**CLEVELAND HOPKINS
INTERNATIONAL AIRPORT
CLEVELAND, OHIO**

Project Title RTA TUNNEL MEMBRANE REPLACEMENT			
Sheet Title SHEET INDEX AND SUMMARY OF QUANTITIES			
Designed: MSI	Drawn: MSI	Checked: LGW	Approved: LGW
Scale: AS SHOWN		Project No.: 198348	
Date: FEBRUARY 2024		Sheet: C-2

2/26/2024 Prebid Questions:

Sheet Title: TUNNEL REPAIR - WATERPROOFING DETAILS

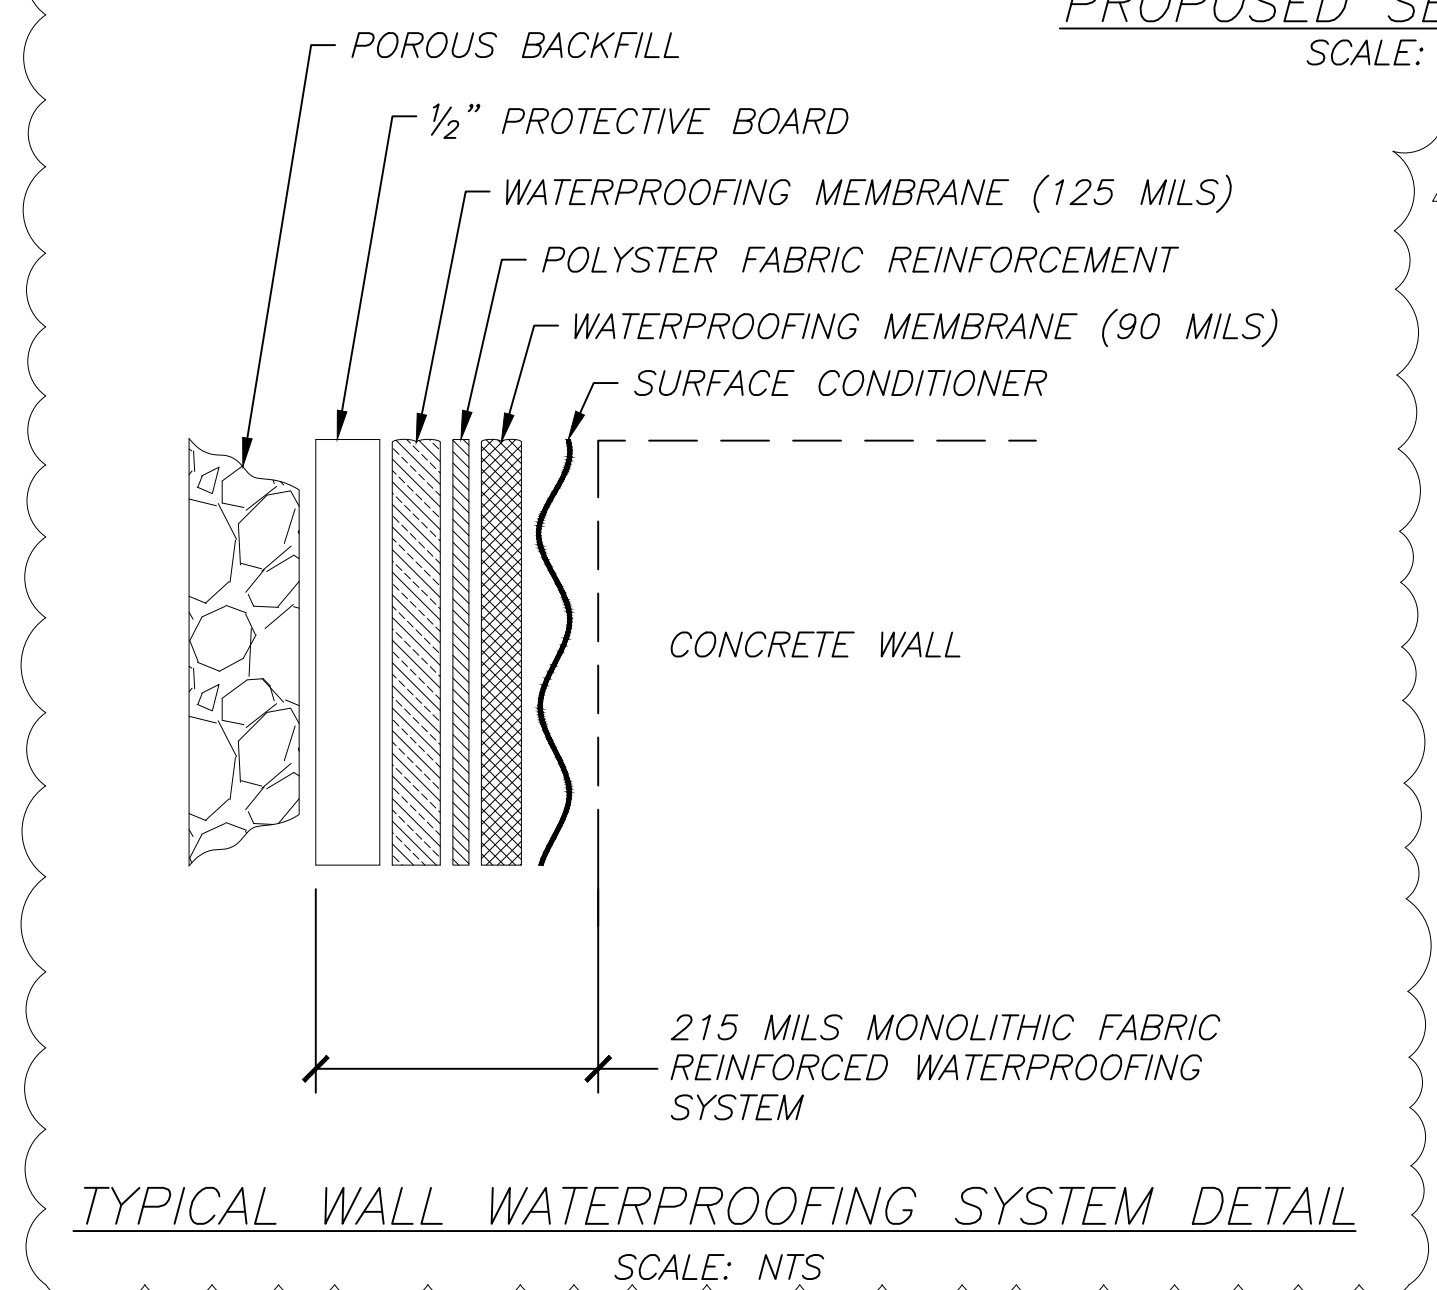
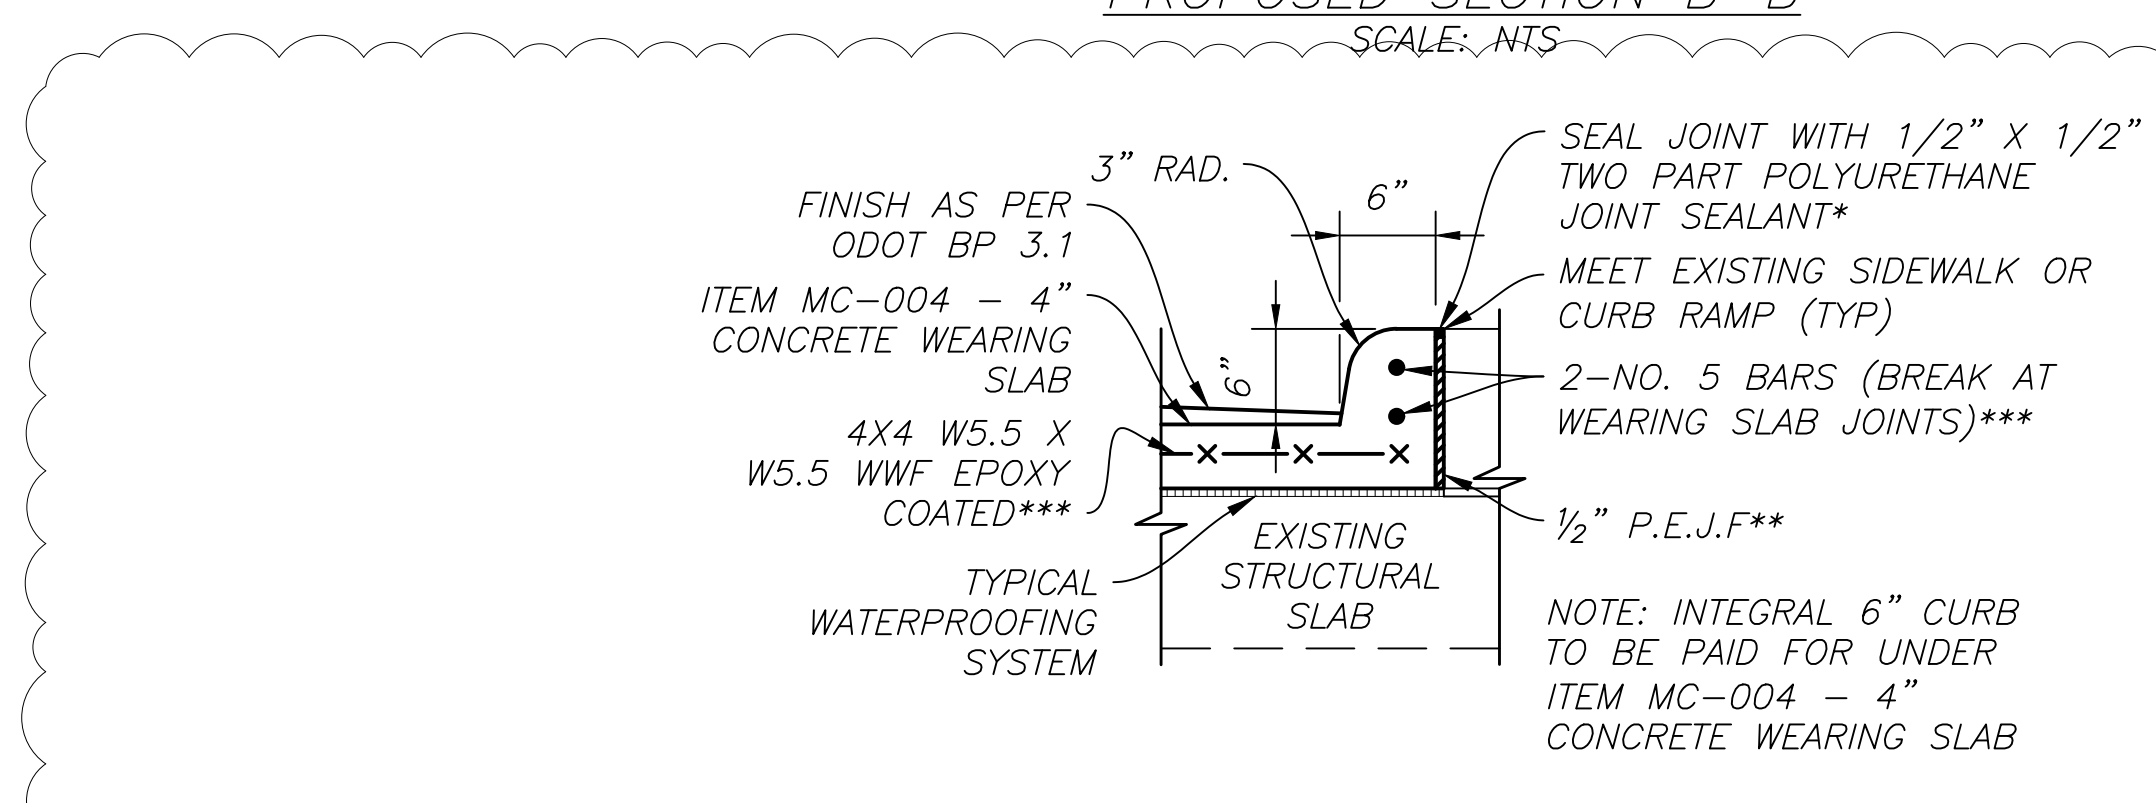
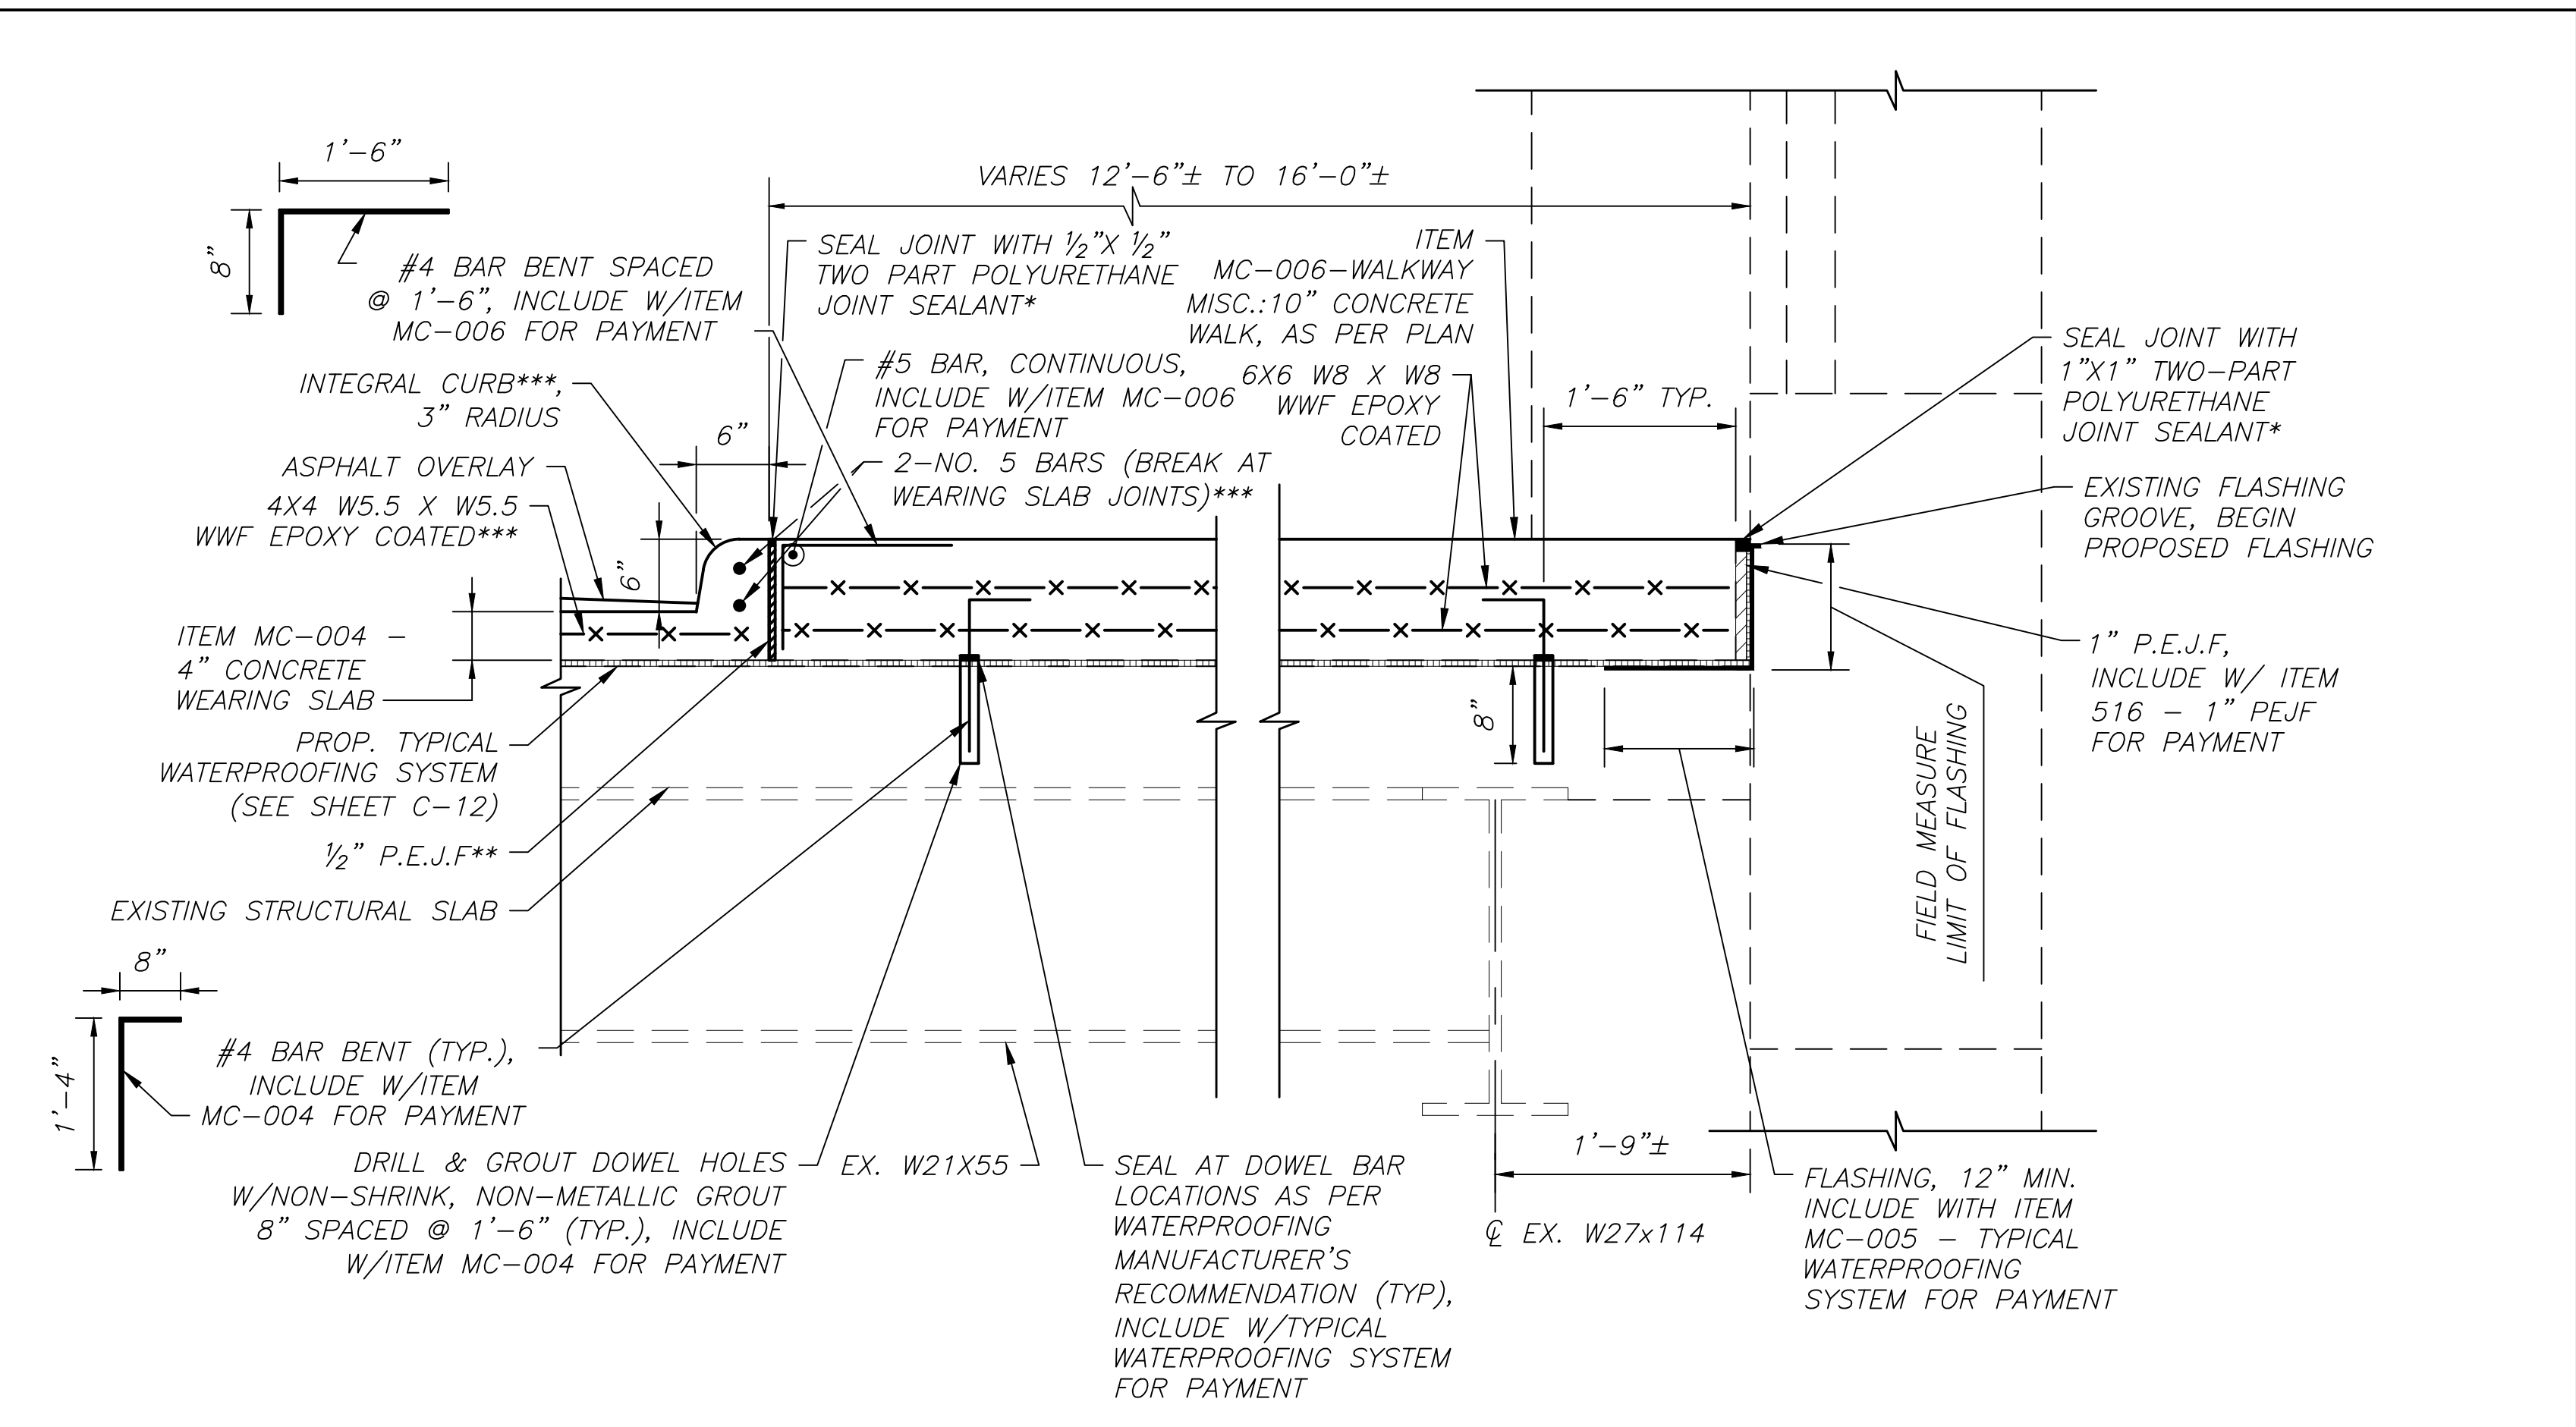
Question: Plan Sheet C-17, Foam Flashing Detail, states to provide "premolded joint material". Please provide specified type and size to be installed.

Answer: The foam flashing detail has been removed. Please see Sheet C-19 for flashing details.
